ADDENDUM #2

NOTICE TO ALL BIDDERS FOR
CITY OF WINCHESTER

ITB #202005 – Valley Avenue Improvements

PROJECT	SHEET NO.
U000-138-R04	20(9)

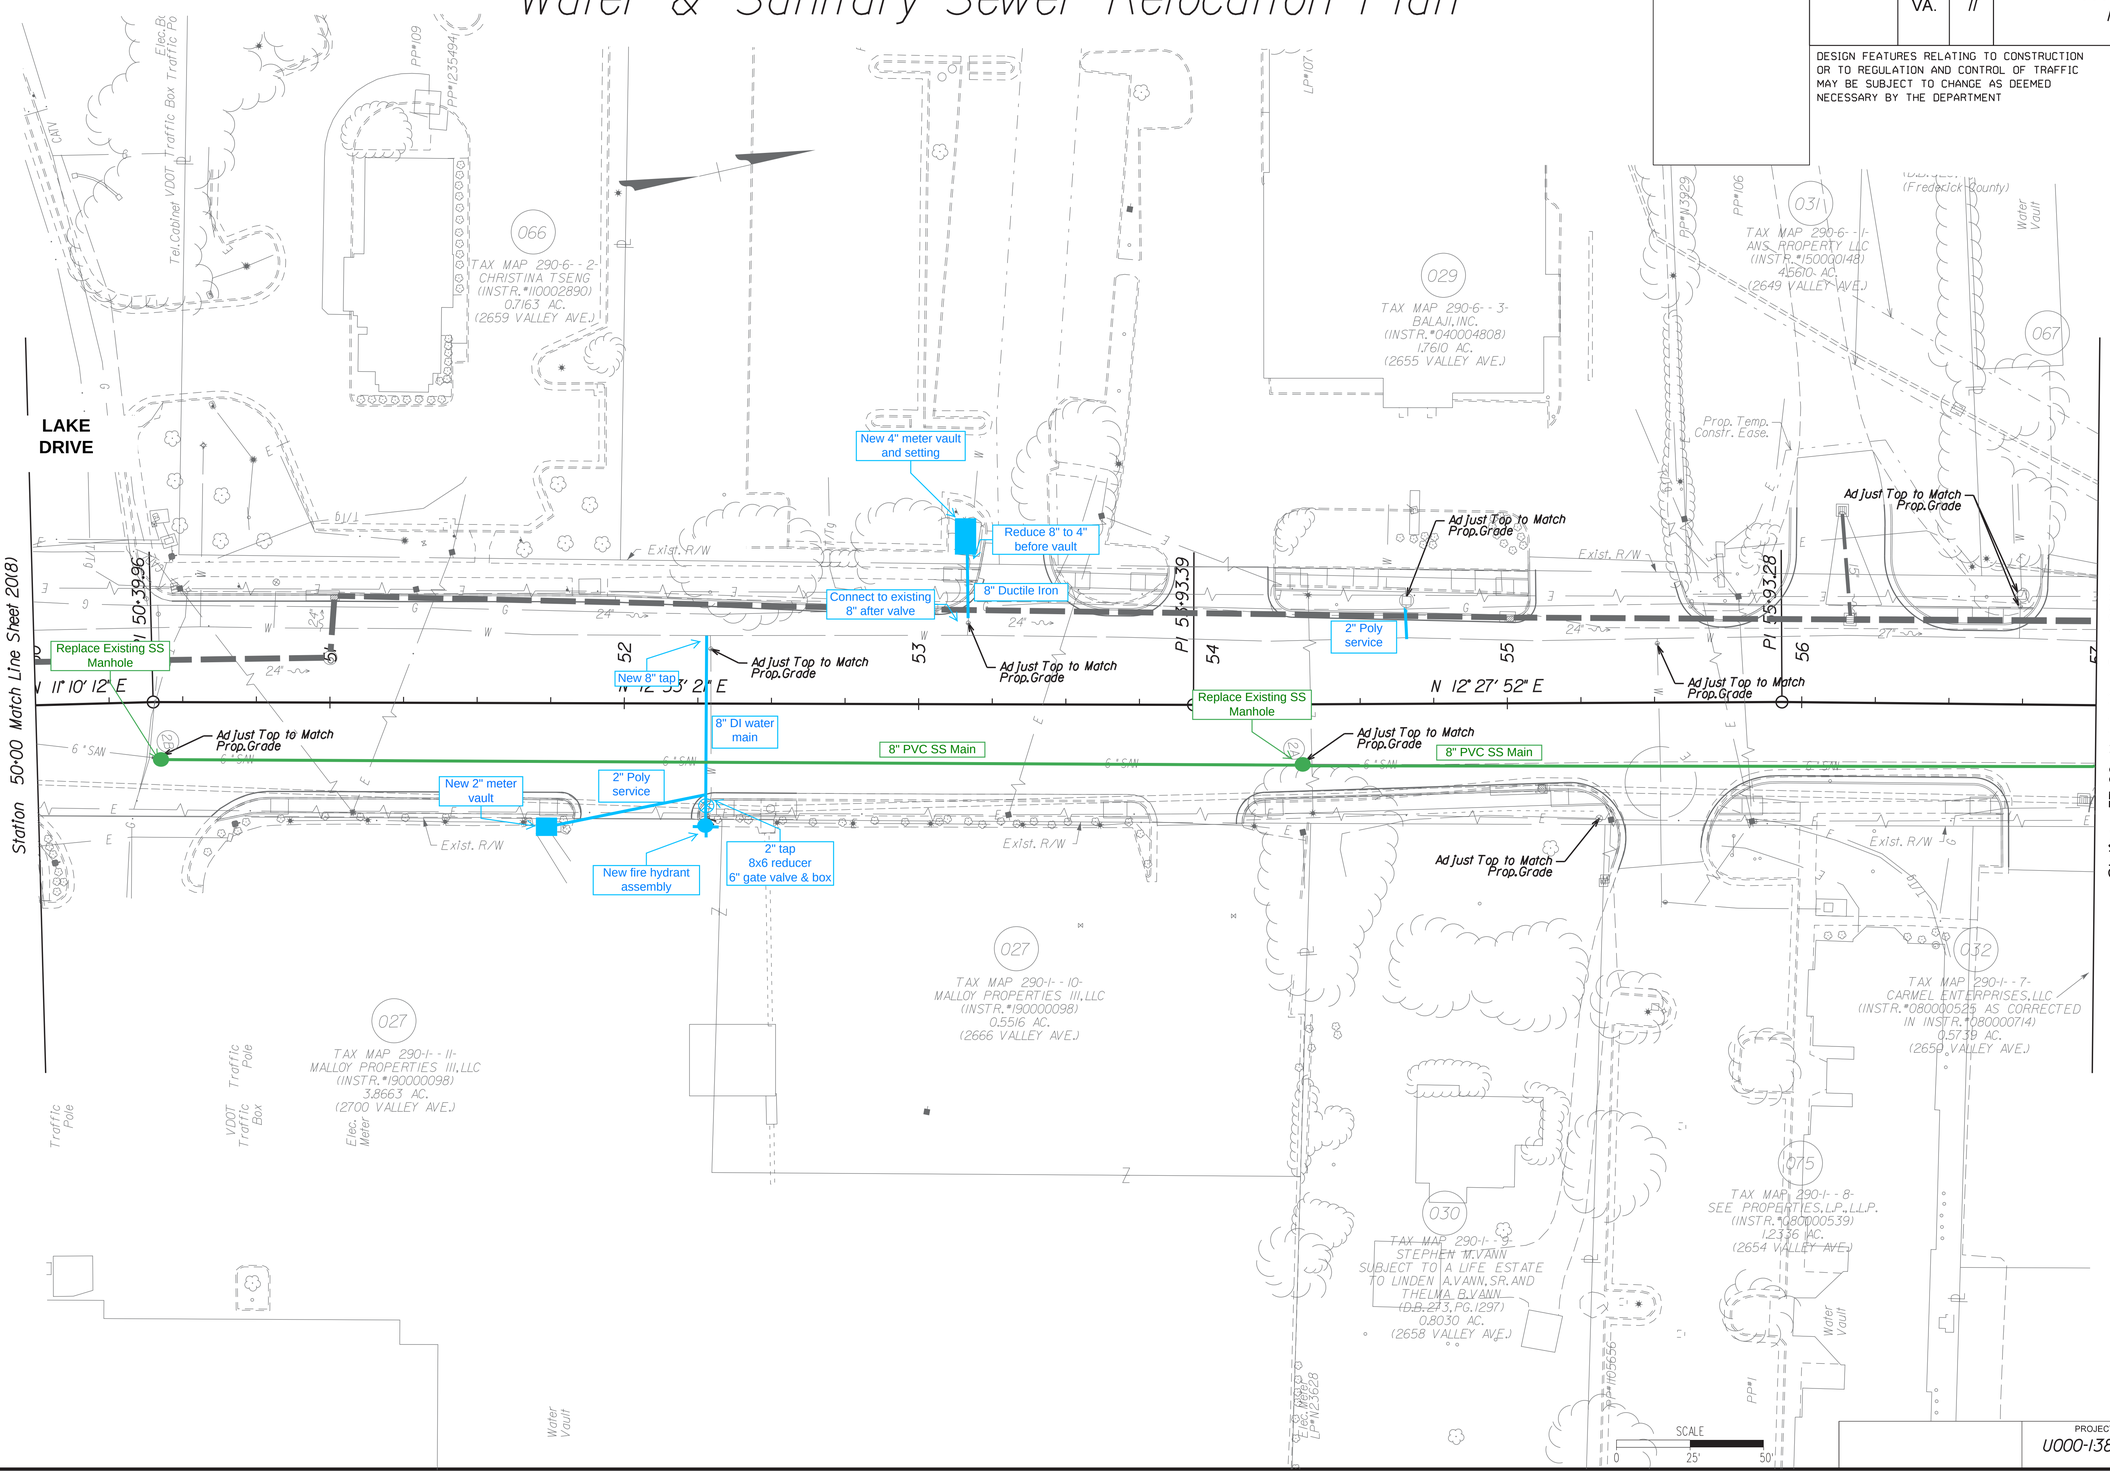
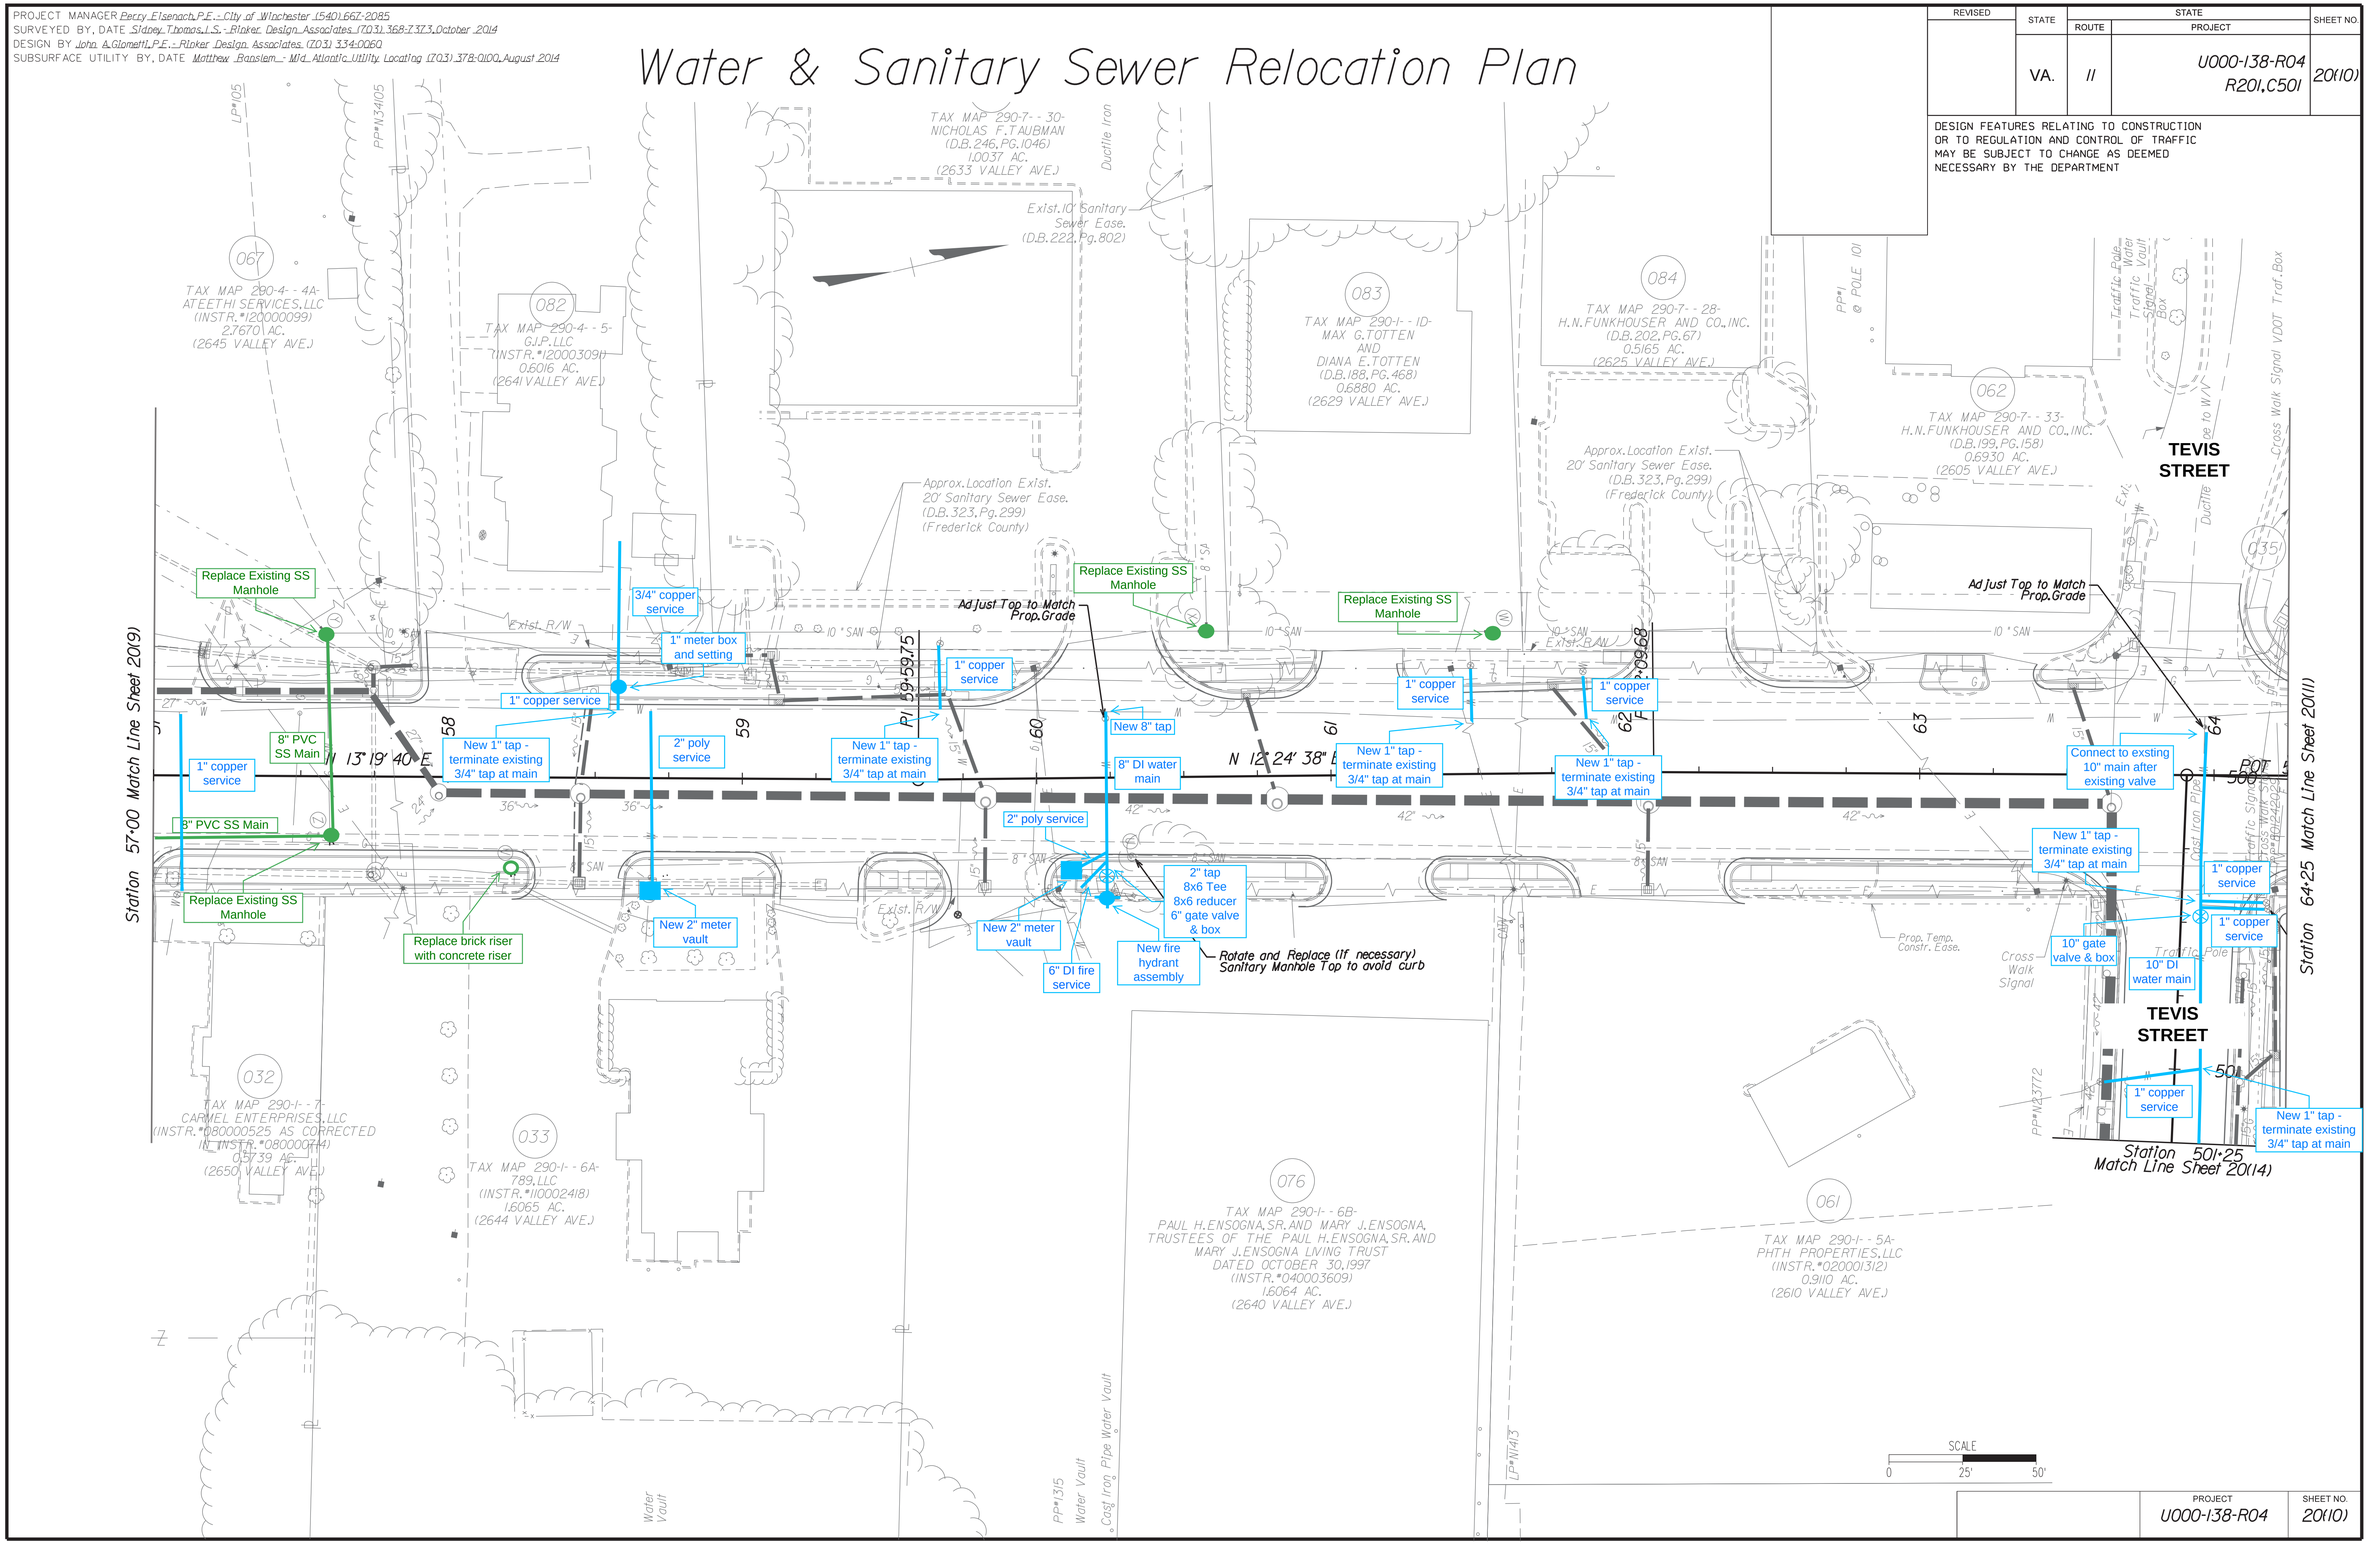
6. There have been numerous additions made to the water and sewer replacements for this project that are included in the revised Bid Form. The original plans have been modified with color showing this information and are attached.
